ARCHITECTURAL REVIEW BOARD MEETING

APRIL 25, 2023 IN THE CITY COUNCIL CONFERENCE ROOM AT 5:00 PM

PROJECT NUMBER: SP2023-013
PROJECT NAME: Site Plan for Alkaios Transportation
SITE ADDRESS/LOCATIONS: 1209 N GOLIAD ST

PROJECT NUMBER: SP2023-014
PROJECT NAME: Amended Site Plan for 108 St. Marys
SITE ADDRESS/LOCATIONS: 108 ST MARYS ST

date: 4/12/23 scale: 1" = 20' sheet: C101

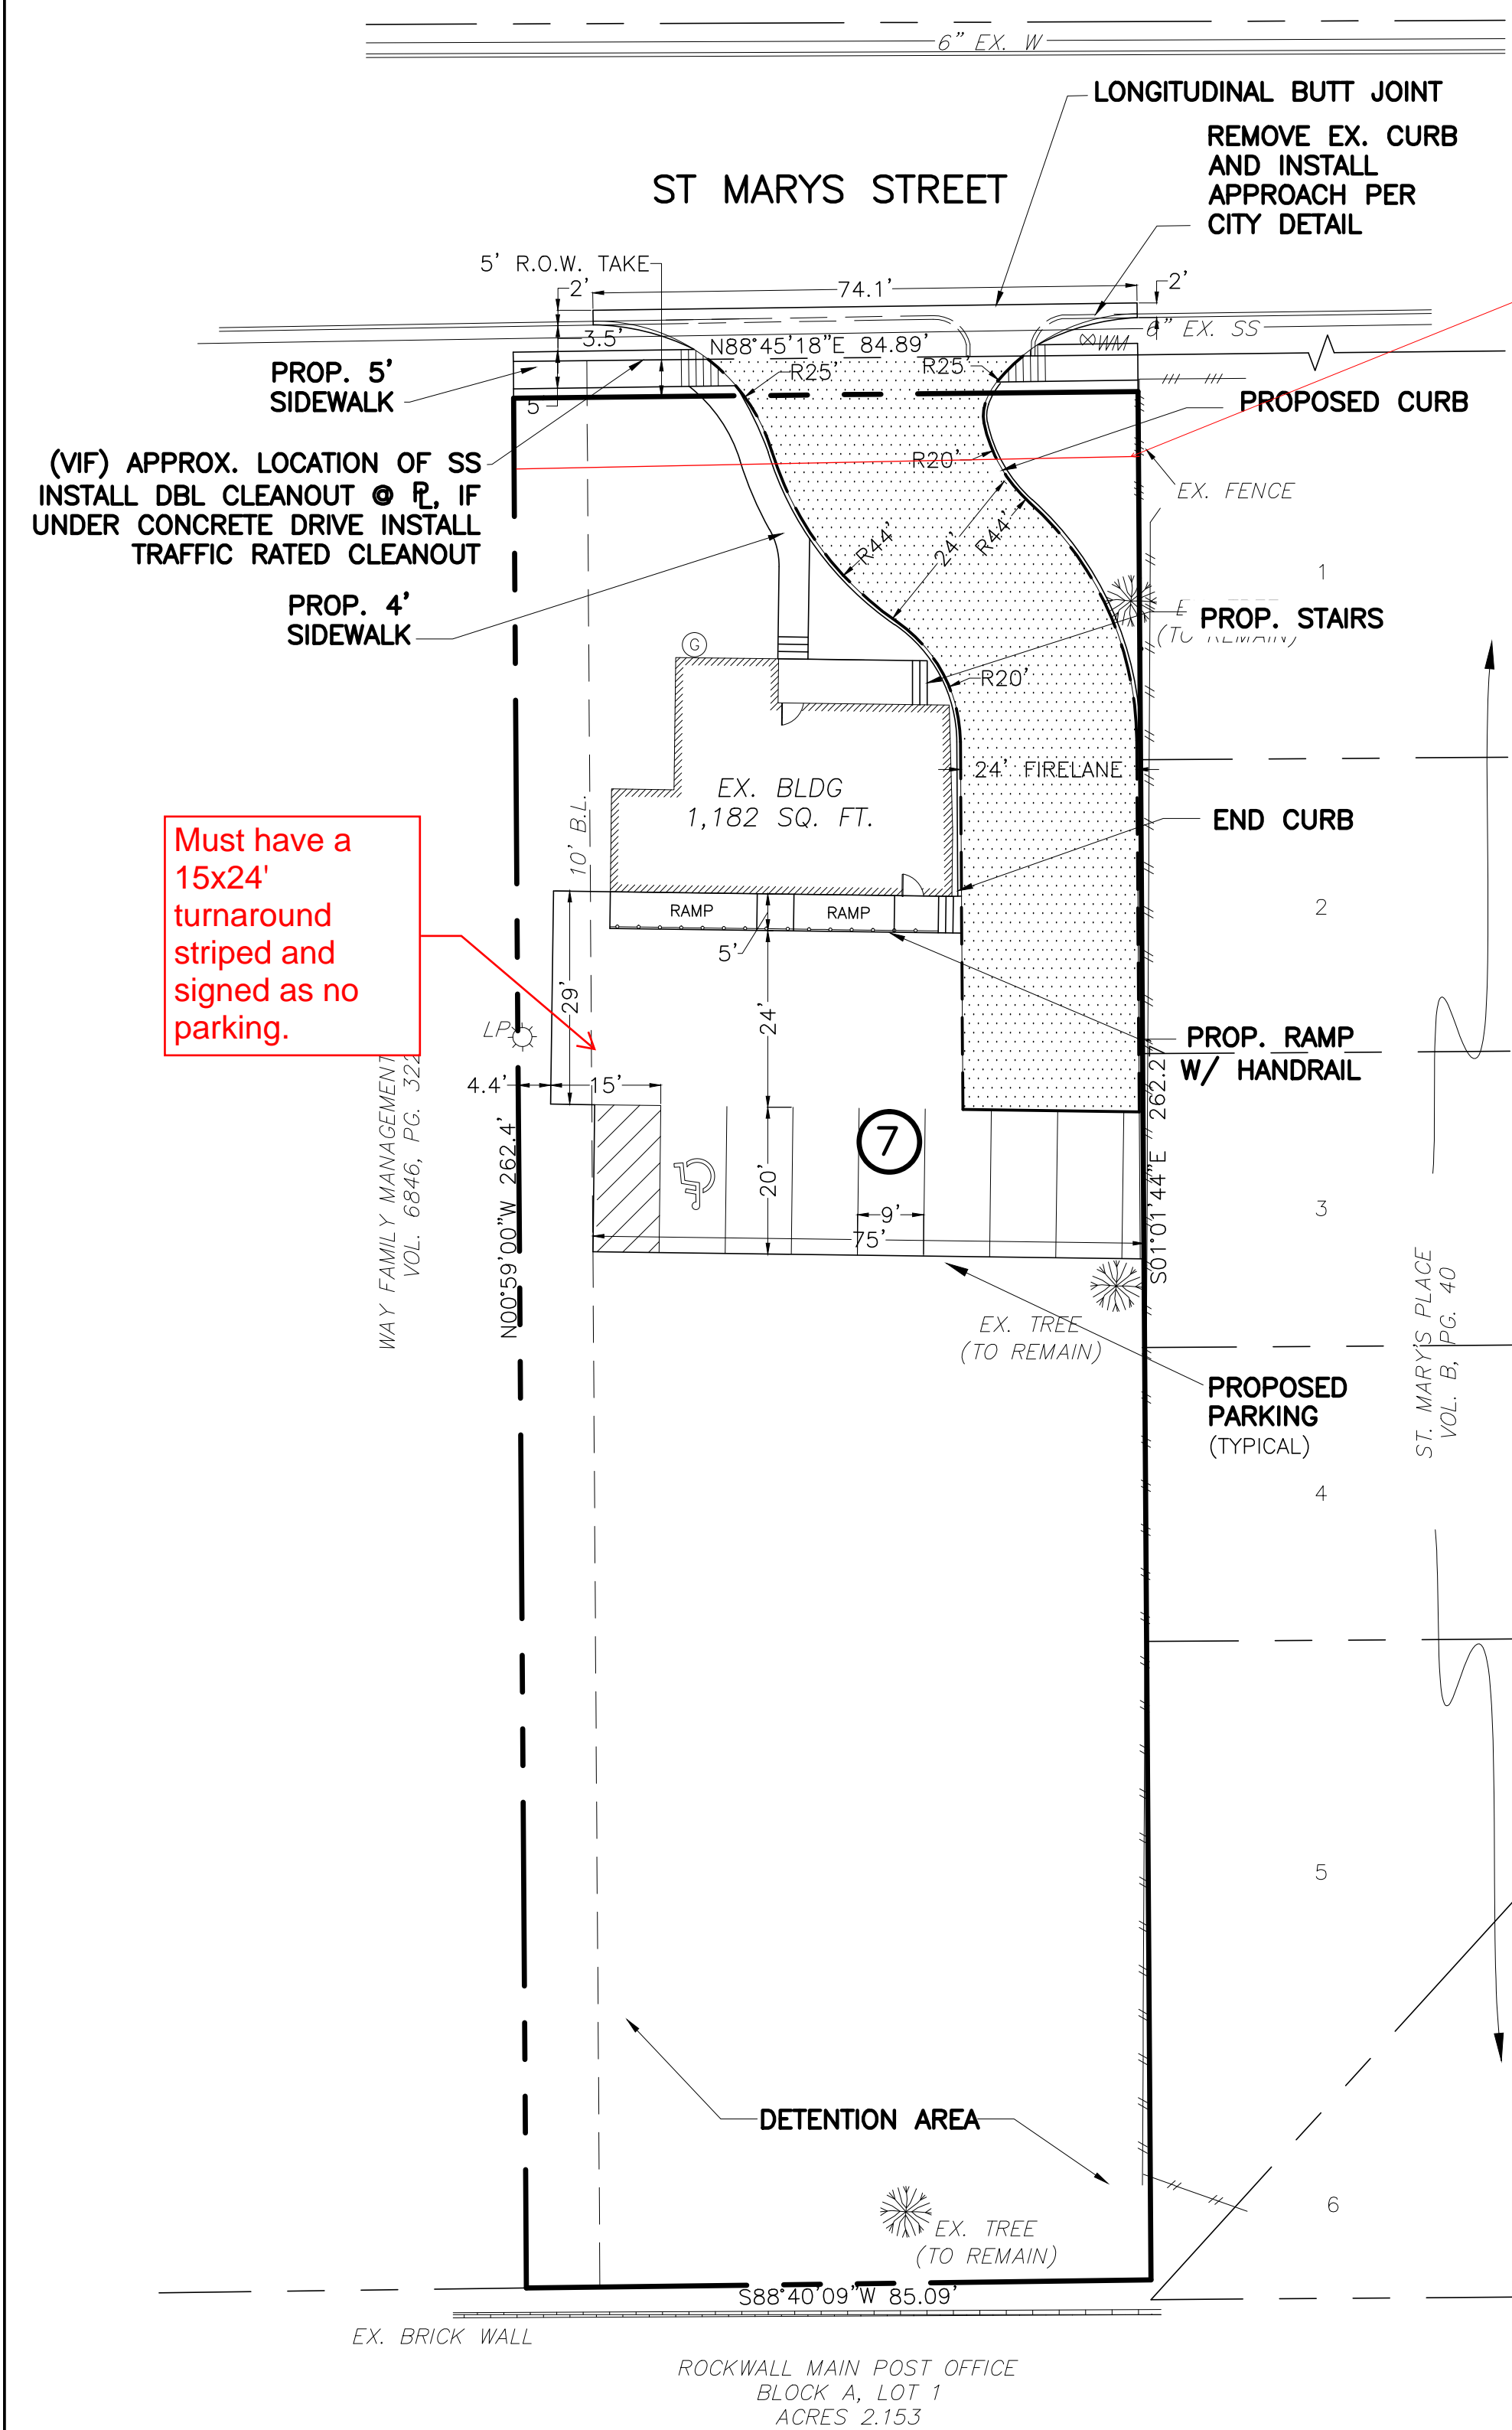
- 4% Engineering Inspection Fees
- Impact fees.
- Min 20' utility easements.
- No structures in easements.
- Fire lane easement to be on plat.
- Fire lane to be 24' wide with 20' radii.
- Parking to be 20'x9'
- No dead-end parking, without approved turn around area.
- Driveway spacing must be labeled on Site Plan.
- Must have detention for added impervious area. No vertical walls allowed in detention easement
- No trees within 5' of public utilities.
- Retaining walls 3' and over must be designed by a licensed engineer. All walls to be rock or stone. No smooth concrete walls.
- Must meet all City Engineering Standards.
- Will need fire hydrant installed at corner of Barnes and St. Marys
- Add note: No dumpster will be used.

1 BUILDING ELEVATION - SOUTH
 1/4" = 1'-0"

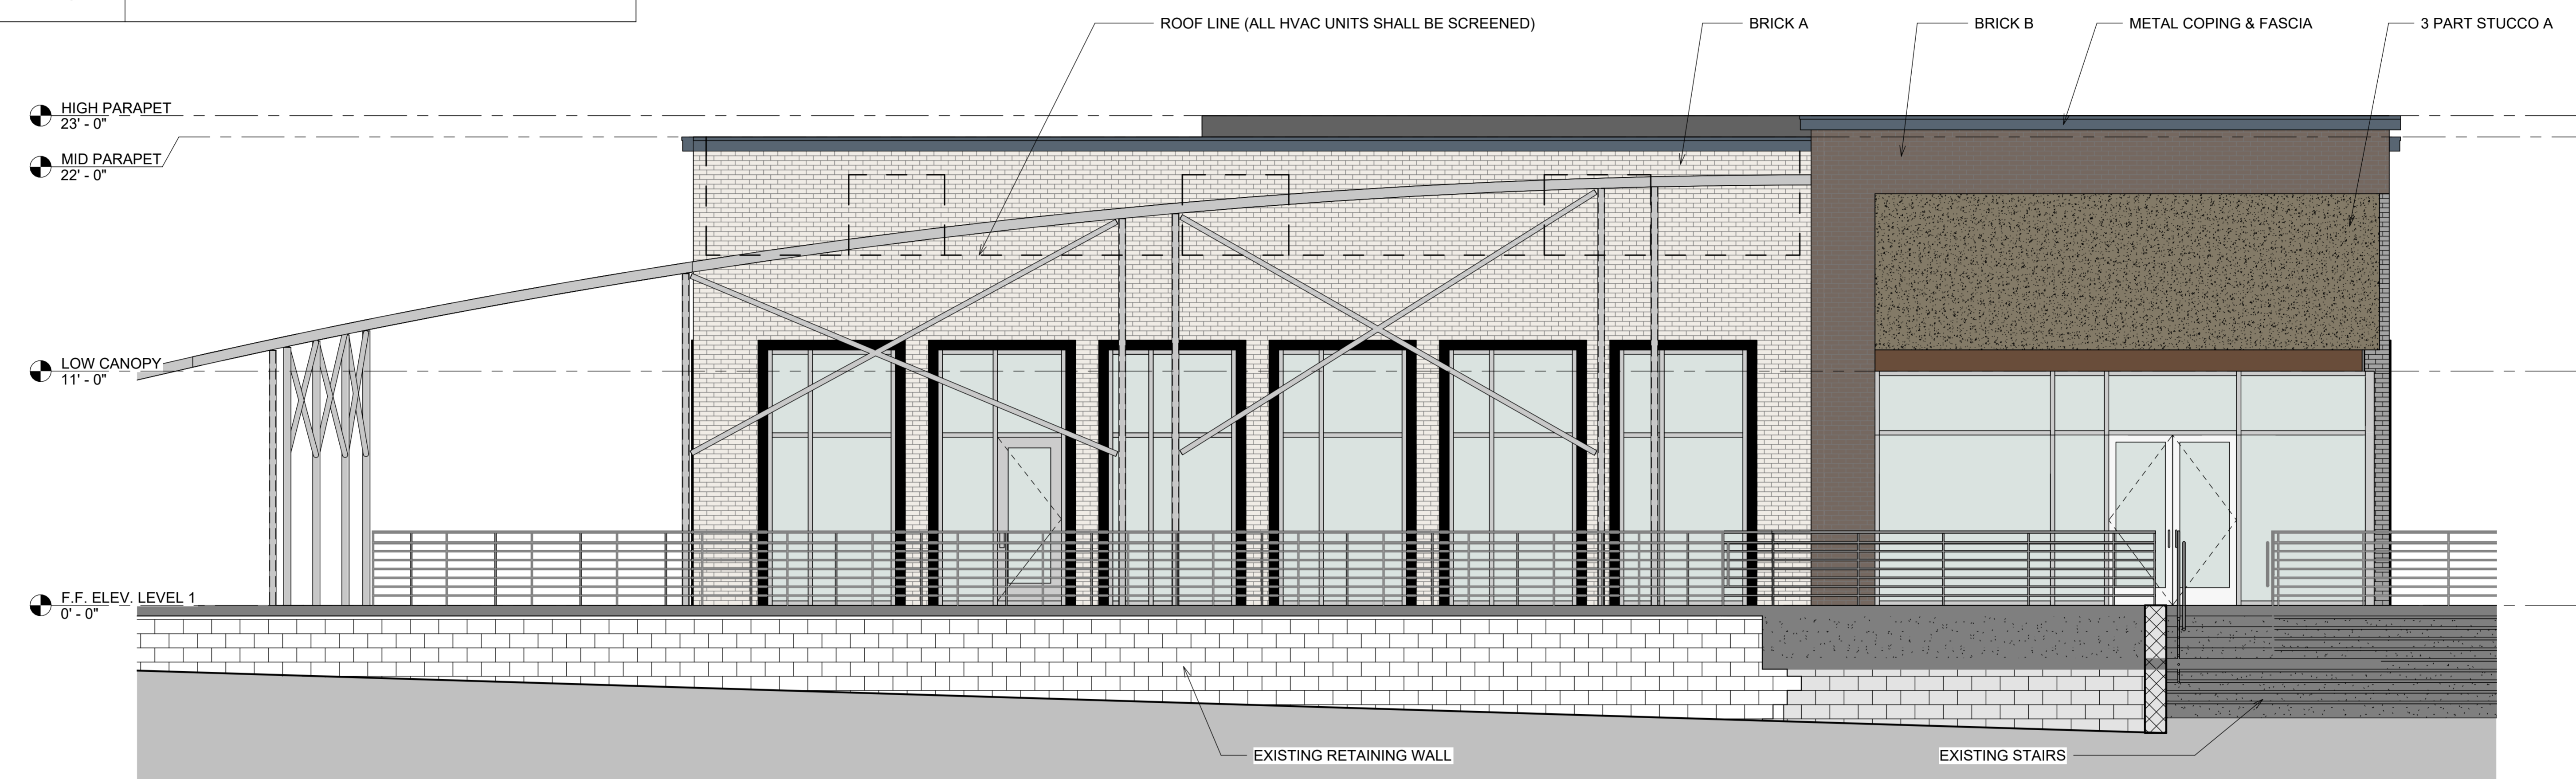
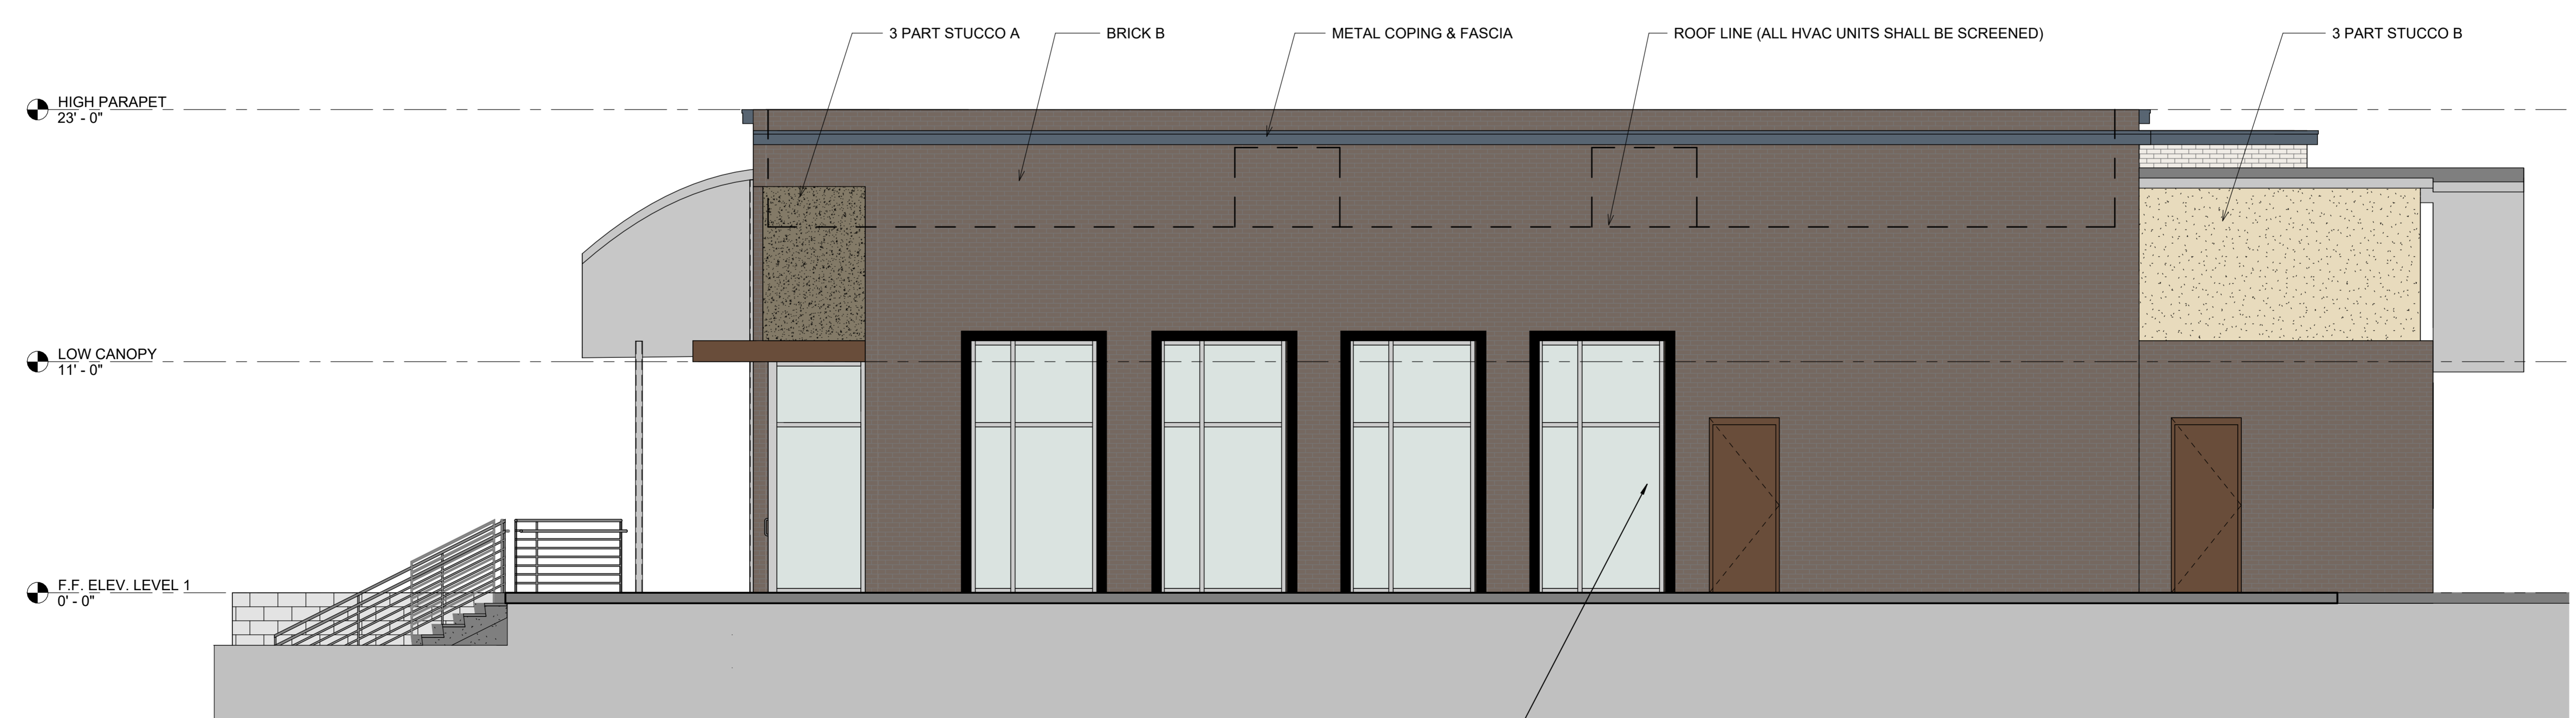
- (4) A minimum of 20% natural or quarried stone is required on all building façades in an Overlay District. (Subsection 06.02.C.1(a)(1), of Article 05, of the UDC). This will require a variance from the Planning and Zoning Commission.

- (5) The proposed buildings' facades do not meet the Commercial Building Articulation Standards for wall projections. (Subsection 04.01.C, of Article 05, of the UDC) This will require a variance from the Planning and Zoning Commission.

- (6) All structures that have a building footprint of less than 6,000 SF shall be constructed with a pitched roof. (Subsection 06.02.C.2, of Article 05, of the UDC) This will require a variance from the Planning and Zoning Commission.

- (7) All buildings shall be architecturally finished on all four (4) sides utilizing the same materials, detailing, articulation and features. (Subsection 06.02.5, of Article 05, of the UDC and Planned Development District 32 [Ordinance 19-25]). This will require a variance from the Planning and Zoning Commission. For compensatory, dress up the South elevation with a couple architectural elements (i.e. an arcade) and varying materials as this elevation will be visible from Sunset Ridge.
